SUBJECT: ISSUANCE OF CORRECT TECHNICAL SPECIFICATION PAGES  
(TAC NOS. 60281 AND 60282)

Enclosed are the correct Technical Specification (TS) pages for Operating License Nos. DPR-71 and DPR-62 for Amendment Nos. 114/141 and for Amendment Nos. 115/142. The Amendment Nos., as listed in the lower right hand corner of the pages, were incorrect on some of the pages. All pages are being reissued.

Brunswick Steam Electric Plant  
Units 1 and 2

ATTACHMENT TO LICENSE AMENDMENT NO. 114

FIGURE 3.4.1.1-1  
THERMAL POWER LIMITATIONS

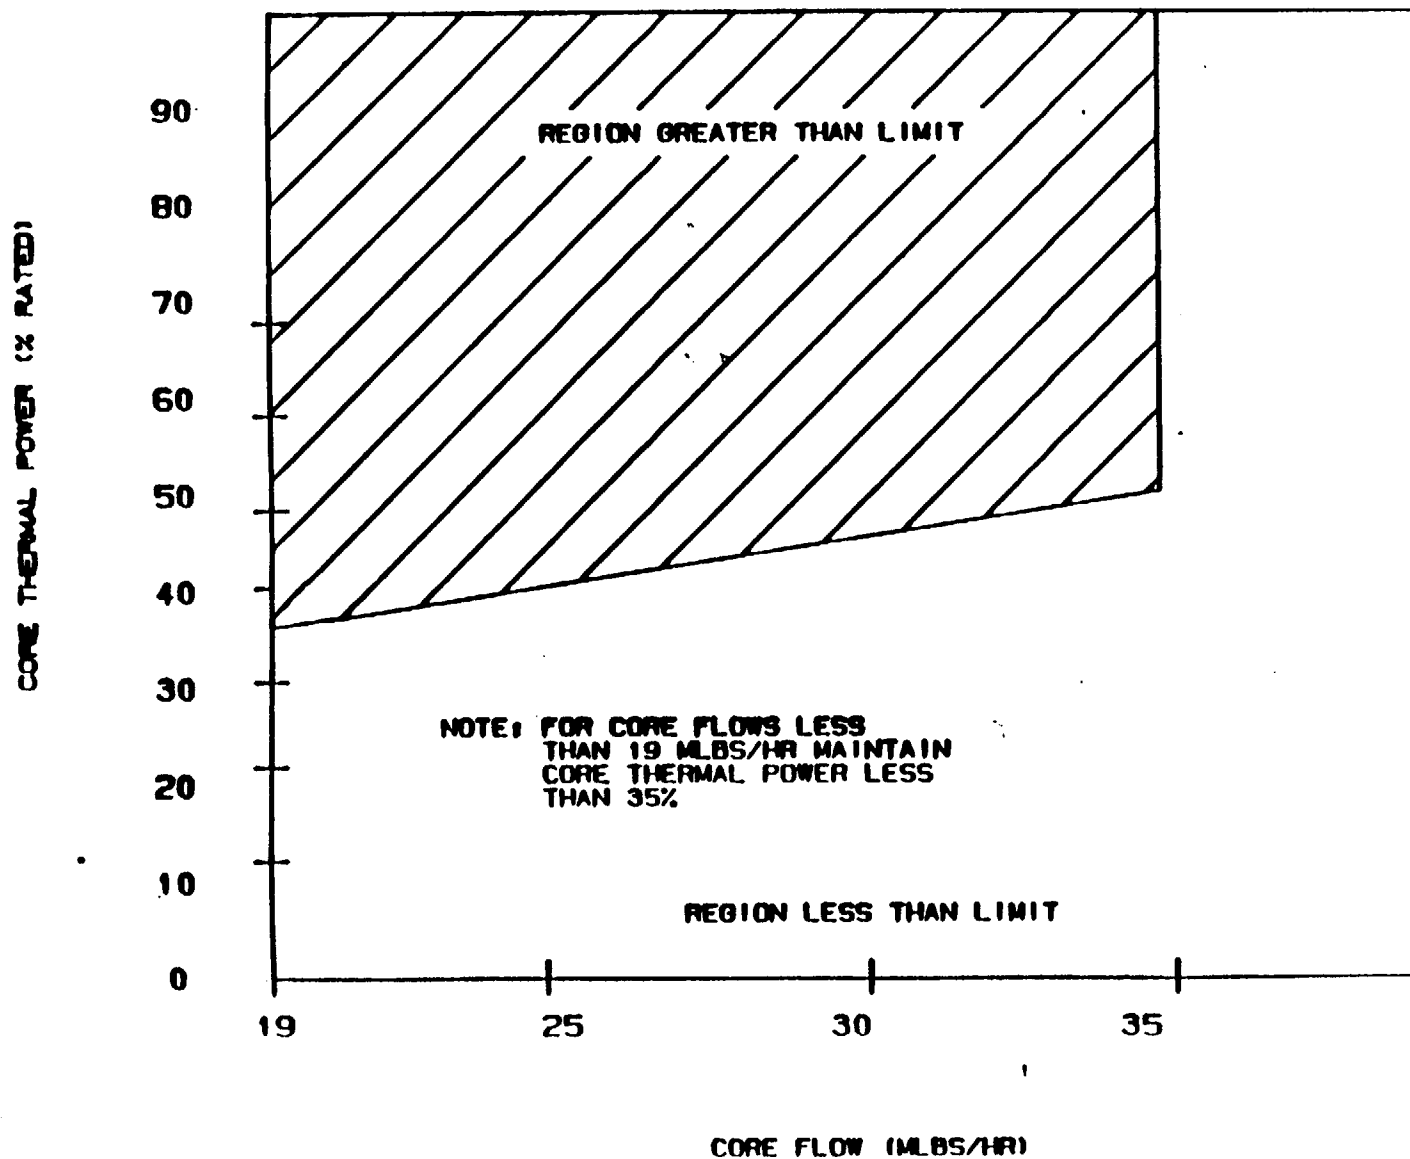
- a. Total core flow shall be greater than or equal to 35 million lbs/hr, or
- b. THERMAL POWER shall be less than or equal to the limit specified in Figure 3.4.1.1-1.

- a. With both reactor coolant system recirculation loops not in operation, immediately initiate an orderly reduction of THERMAL POWER so that it is less than or equal to the limit specified in Figure 3.4.1.1-1 within 2 hours, and restore both loops to operation within 12 hours or be in at least HOT SHUTDOWN within the next 12 hours.

- b. With one reactor coolant system recirculation loop not in operation, immediately initiate either an orderly reduction of THERMAL POWER so that it is less than or equal to the limit specified in Figure 3.4.1.1-1 within 2 hours or increase core flow so that it is greater than or equal to the limit specified in Figure 3.4.1.1-1 within 2 hours, and restore both loops to operation within 12 hours or be in at least HOT SHUTDOWN within the next 12 hours.

- c. With two reactor coolant system recirculation loops in operation and total core flow less than 35 million lbs/hr and THERMAL POWER greater than the limit specified in Figure 3.4.1.1-1:

1. Immediately initiate action to reduce THERMAL POWER so that it is less than or equal to the limit specified in Figure 3.4.1.1-1 within 2 hours, or

FIGURE 3.4.1.1-1  
THERMAL POWER LIMITATIONS

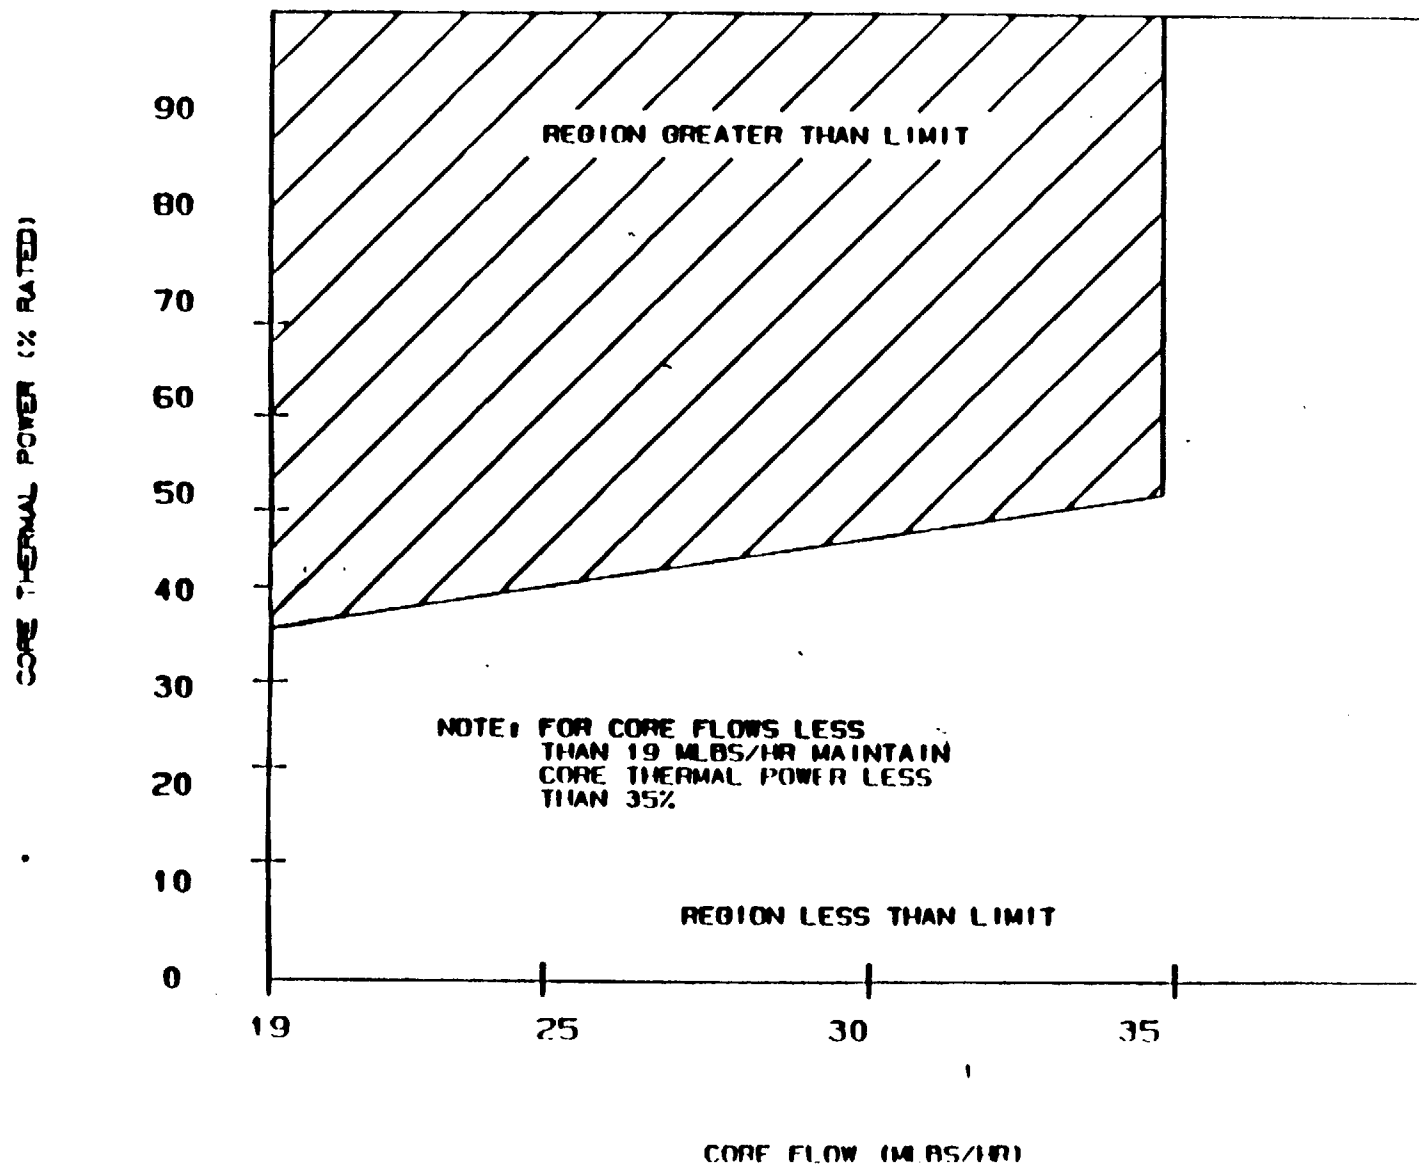
- a. Total core flow shall be greater than or equal to 35 million lbs/hr, or
- b. THERMAL POWER shall be less than or equal to the limit specified in Figure 3.4.1.1-1.

- a. With both reactor coolant system recirculation loops not in operation, immediately initiate an orderly reduction of THERMAL POWER so that it is less than or equal to the limit specified in Figure 3.4.1.1-1 within 2 hours, and restore both loops to operation within 12 hours or be in at least HOT SHUTDOWN within the next 12 hours.

- b. With one reactor coolant system recirculation loop not in operation, immediately initiate either an orderly reduction of THERMAL POWER so that it is less than or equal to the limit specified in Figure 3.4.1.1-1 within 2 hours or increase core flow so that it is greater than or equal to the limit specified in Figure 3.4.1.1-1 within 2 hours, and restore both loops to operation within 12 hours or be in at least HOT SHUTDOWN within the next 12 hours.

- c. With two reactor coolant system recirculation loops in operation and total core flow less than 35 million lbs/hr and THERMAL POWER greater than the limit specified in Figure 3.4.1.1-1:

1. Immediately initiate action to reduce THERMAL POWER so that it is less than or equal to the limit specified in Figure 3.4.1.1-1 within 2 hours, or
